Berkshire Pointe JSP13-47

Approval of the request of Ivanhoe Companies for Revised Phasing Plan approval. The subject property is located in Section 18, on the west side of Wixom Road, south of Grand River Avenue in the RM-1, Low Density Low-Rise Multiple-Family Residential District (with a Planned Rezoning Overlay). The subject property is 29.20 acres and the applicant is proposing to revise the previously approved phasing plan of an 86 unit single-family residential development from a three-phase plan to a one-phase plan.

Planning Review

SUBJECT: Berkshire Pointe, JSP13-0047; Traffic Review of Final Site Plan, PSP14-0016

SITE AND PAVING PLAN
BERKSHIRE POINT
NOVI, MICHIGAN, SECTION 18

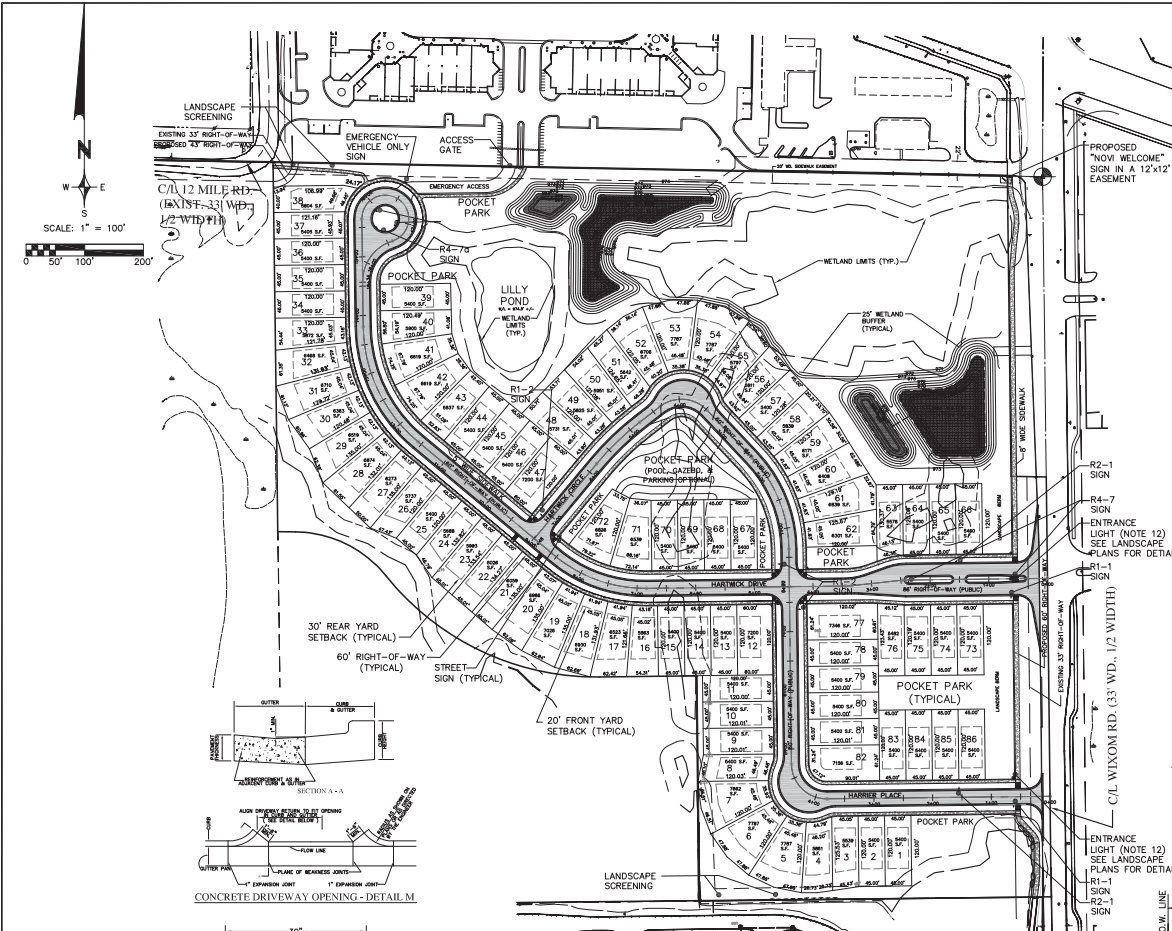
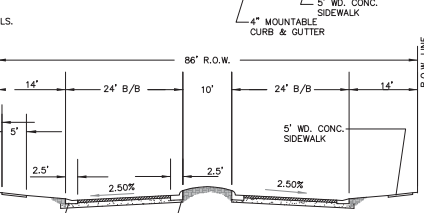
2. Revised Phasing: The applicant has adjusted the proposed phasing and indicated the entire site will be completed as one phase. **This change requires the approval of the Planning Commission and the matter will be scheduled for an upcoming meeting.**

Figure 1. Site Aerial Photo (Google Earth, imagery date May 9, 2010, assessed March 7, 2014). Approximate property boundary shown in red.

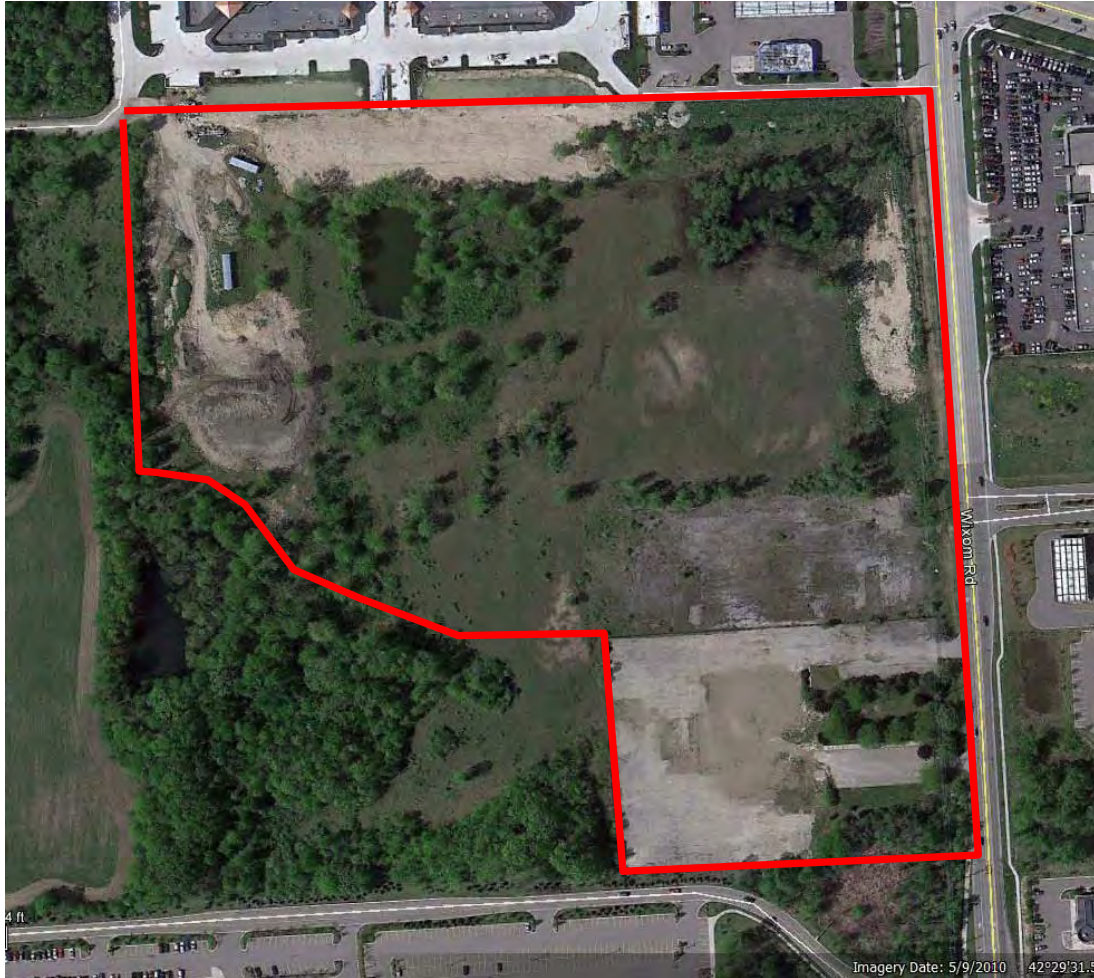
The entire site is approximately 29.15 acres with regulated woodland mapped across a portion of the property (generally in the southwest corner of the site). See Figure 1 (aerial photo).

As shown, there appear to be substantial woodland impacts associated with the site construction. It appears as if the proposed work (proposed buildings, roads, utilities and storm water detention basins) will cover the majority of the site and will involve a considerable number of tree removals. Of the trees listed on the Plan, 166 trees will be preserved. The majority of the trees to be preserved are located in and around the existing on-site wetlands.
